## CLARIFICATION 1

ނަންބަރު No:	TES/2022/G-002	
ފޮތްތައް ބަލާފައިވާ Project:	Design, Supply, and Installation of Waste sorting line with sieving equipment and MSW shredder at R. Vandhoo Regional Waste Management Centre	
ފޮތްތައް ބަލާފައިވާ Issued Date	17 <sup>th</sup> March 2022	
ފޮތްތައް ބަލާފައިވާ No. of Pages: -04	ފޮތްތައް ބަލާފައިވާ Boq: -00	ފޮތްތައް ބަލާފައިވާ Drawings: -04

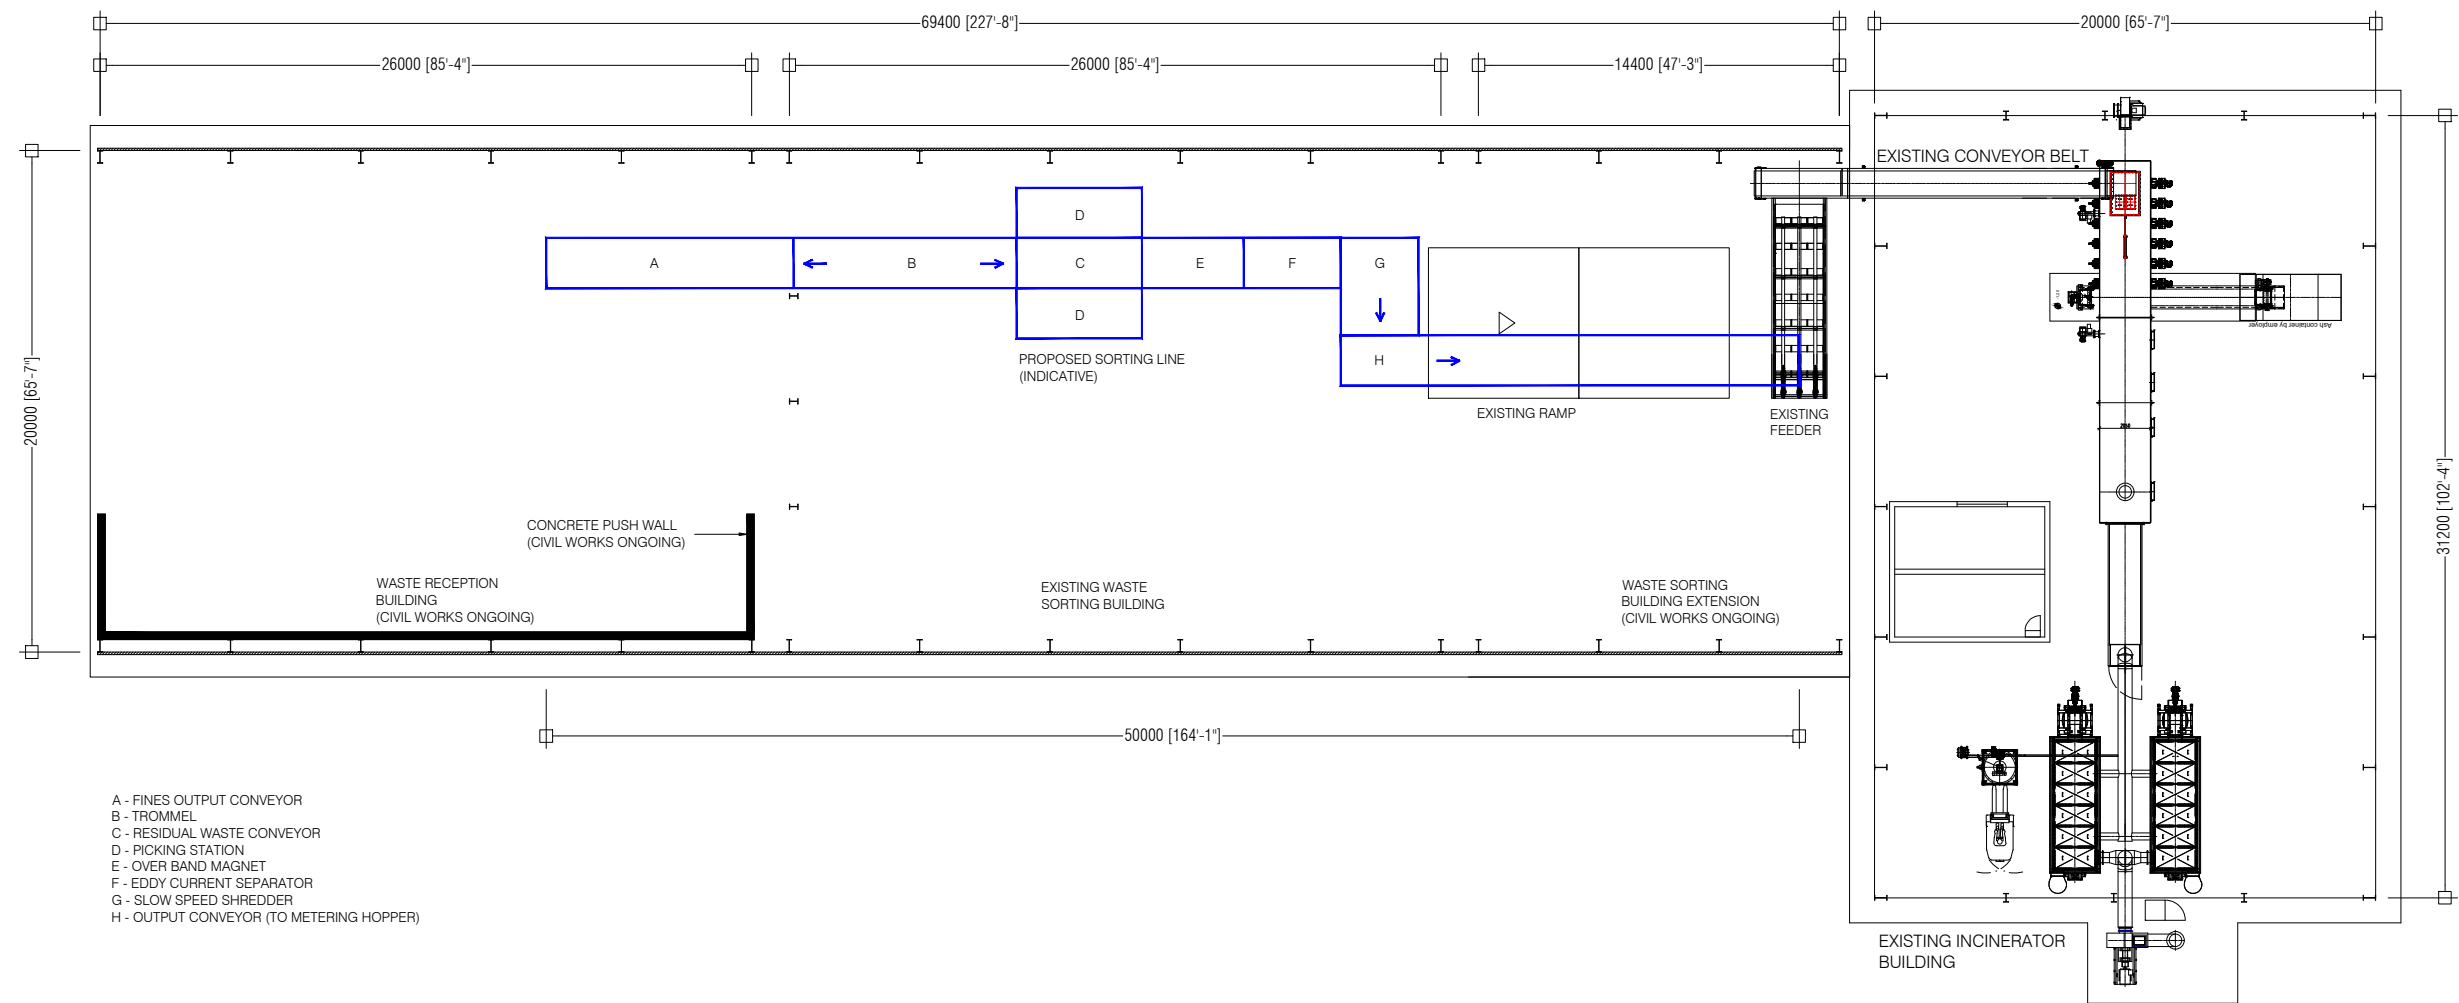
4			Do you have an as -built drawing or render of the R. Vandhoo Regional Waste Management Centre we can work from showing the feed height to the incinerator as we will have to arrange the conveyor feed point to it?	As-built drawings are attached to this
5			Can you also confirm that there is already an existing conveyor feeding the incinerator we could connect to?	Yes, there is already an existing feeding conveyor
6			Can you also confirm that the material being presented to the plant for separation will be loose and not in plastic bags as we understand there is no need for a bag opener at the front end.	both loose and in bags, therefore a bag opener is required as mentioned above
7			Multi crusher - Usually, we design large waste is separate with MSW to go to different waste shredder, but we found the owner need all waste go to in same shredder(crusher). some bulk waste maybe have hard materials such as stone and metal. should we go forward with base on demand of tender? In addition, please confirm the shredder drive is hydraulic motor or electric motor?	crusher is required to shred waste into a certain size and make homogenous. Large and bulky waste are to be separate and will not go into the crusher
